SUBJECT: Forwards proposed Tech Spec change re table notation (B) of  
 Tech Spec Table 2.2-1 to provide lower limit to rate at  
 which variable overpower trip setpoint decreases as reactor  
 power decreased.

Subject: Palo Verde Nuclear Generating Station (PVNGS)  
Units 1, 2 and 3  
Docket Nos. STN 50-528 (License No. NPF-41)  
STN 50-529 (License No. NPF-51)  
STN 50-530 (License No. NPF-65)  
Proposed Technical Specification Change - Variable  
Overpower Trip Function  
File: 87-A-056-026; 87-F-005-419.05

FIGURE 1  
OPERATION OF THE VOPT REACTOR TRIP

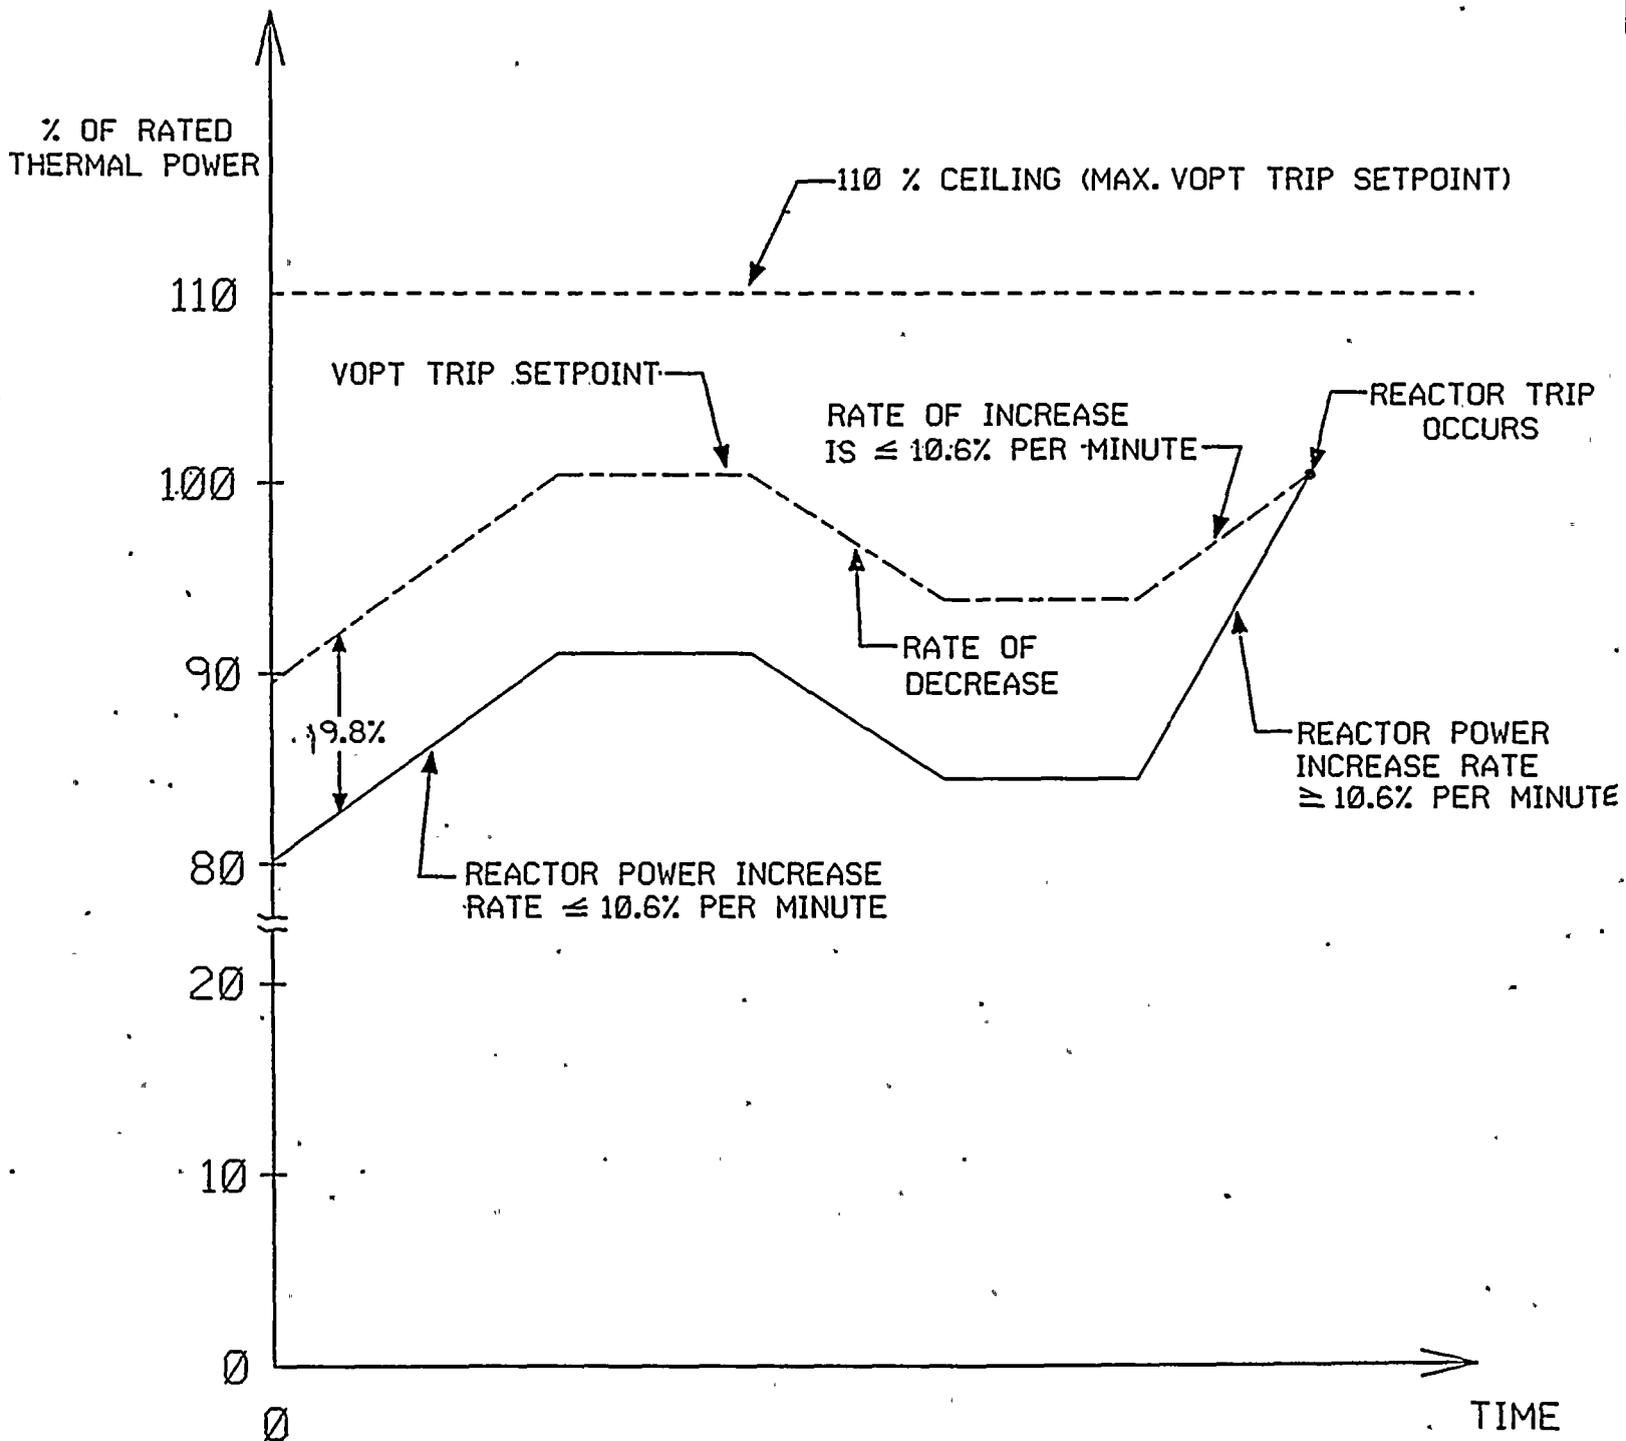
The behavior of the VOPT trip function is shown in Figure 1. The first part (beginning at time = 0) of Figure 1 shows the behavior of the VOPT trip setpoint during normal reactor power increases where the rate of power increase is less than or equal to 10.6% of Rated Thermal Power (RTP) per minute. For this case, the VOPT trip setpoint increases as reactor power increases while maintaining the band of 9.8% RTP between the trip setpoint and actual reactor power. For the second case, where reactor power is decreasing, the VOPT trip setpoint will track the reactor power downward while maintaining the band of 9.8% RTP. The rate of decrease of the VOPT trip setpoint will be limited to no slower than 5% RTP per second upon approval of this proposed Technical Specification change (currently there are no limits on the rate of decrease). For the third case of Figure 1, where reactor power is rapidly increasing at a rate greater than 10.6% RTP per minute, the reactor power is increasing faster than the VOPT trip setpoint is allowed to increase. This situation will eventually lead to a reactor trip as the reactor power either: i) exceeds the variable trip setpoint (as shown in Figure 1), or ii) exceeds the 110% RTP ceiling setpoint.

FIGURE 2

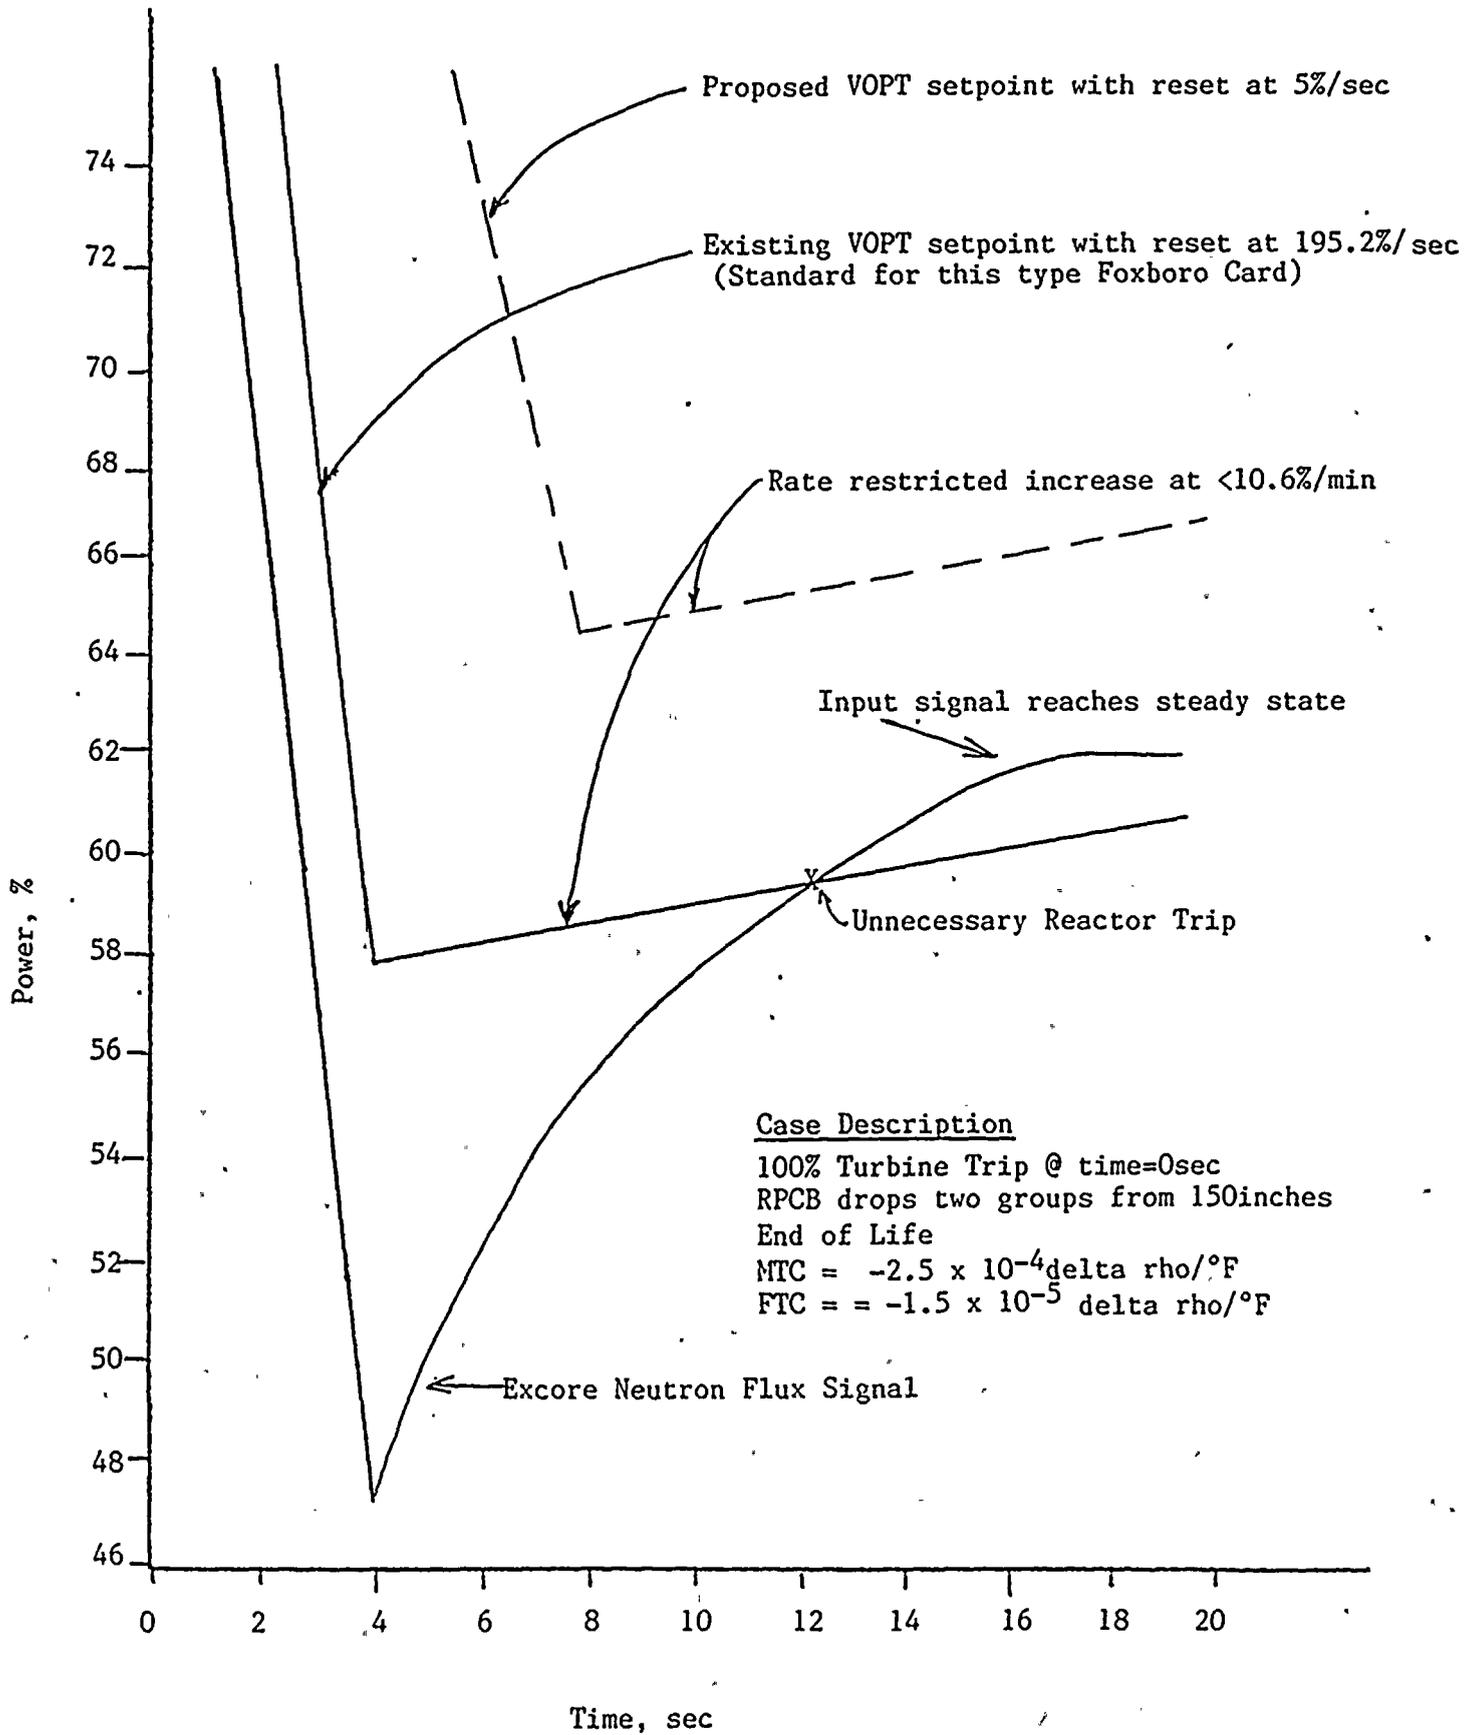
In order to avoid reactor trips during RPCS actuations, it is proposed that the VOPT trip function be modified to limit the rate at which the trip setpoint can decrease in response to decreasing reactor power. If the rate of decrease is set at 5% RTP per second, the results will be as shown on Figure 2. For this case, the VOPT trip setpoint remains above the reactor power following a RPCS actuation and no reactor trip signal is received.

FIGURE 3

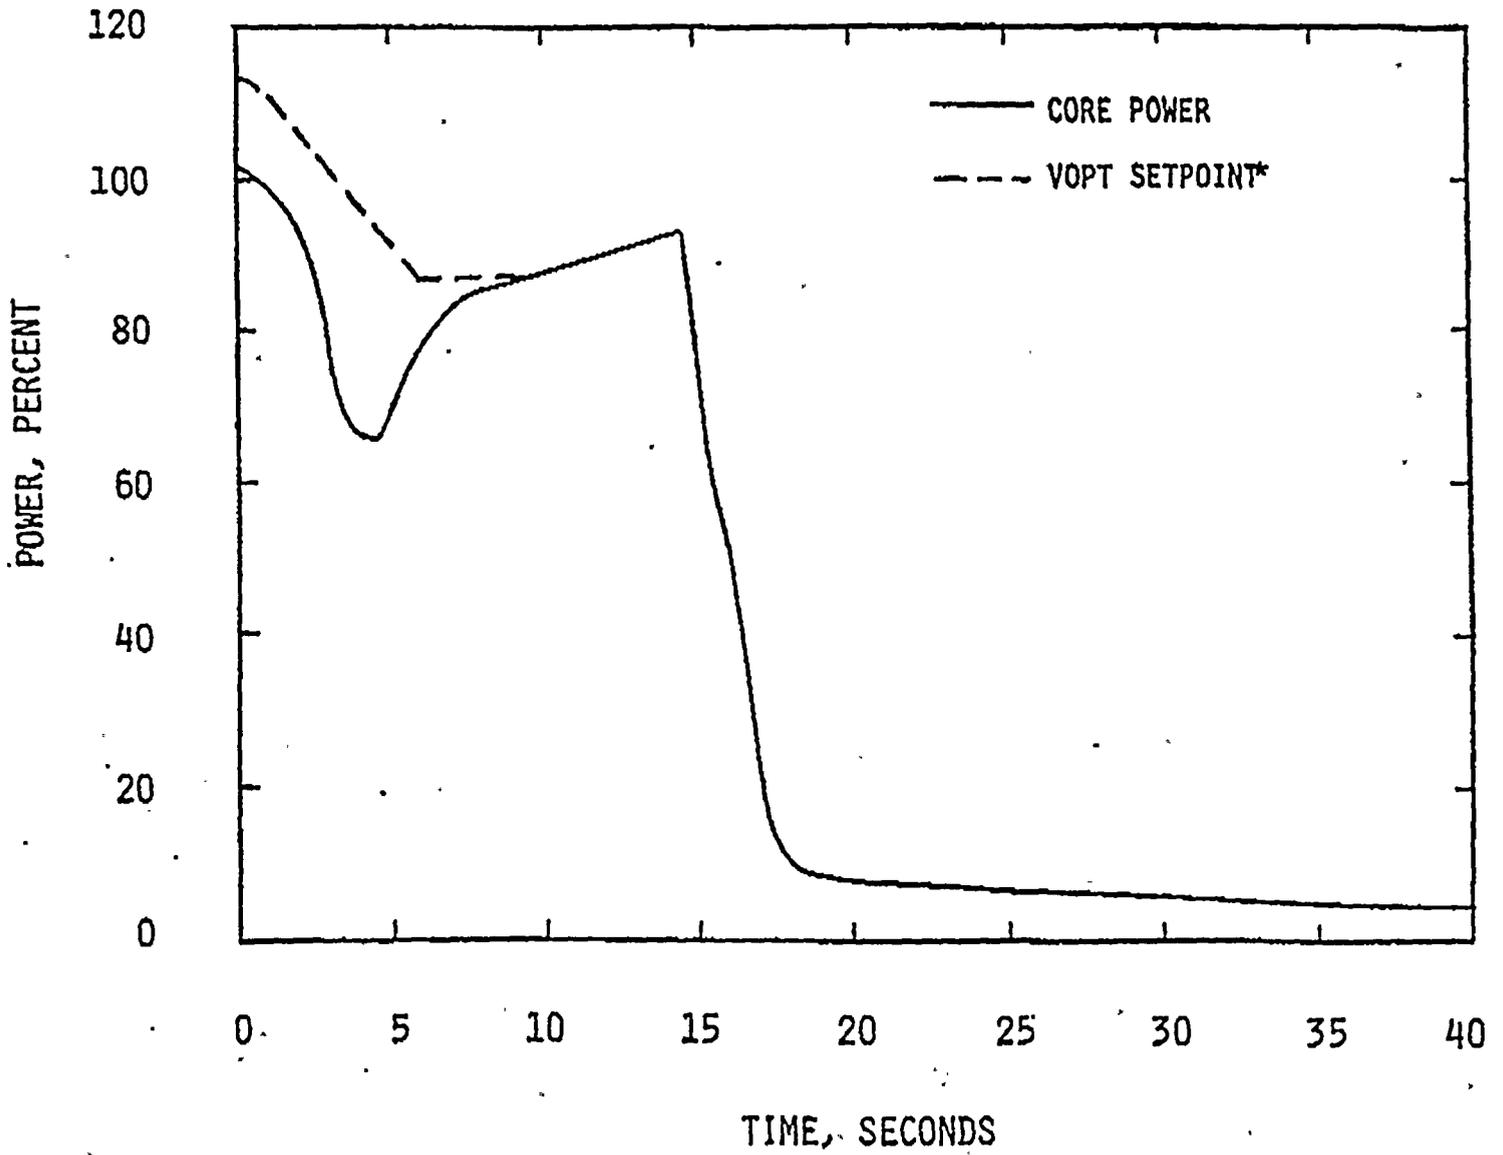
Figure 3 shows the response of both reactor power and the VOPT trip setpoint (assuming 5% RTP per second downward reset rate) during this abnormal reactor power cutback analysis. The sequence of events for this analysis are presented below. It should be noted that the minimum DNBR experienced during this analysis is 1.34 and the maximum linear heat rate is 15.6 kw/ft. Both of these values are acceptable because they are within the Specified Acceptable Fuel Design Limits (SAFDLs) on DNBR and linear heat rate.

\* Note Trip assumed to occur later than that indicated by the intersection of the VOPT setpoint and calculated core power.
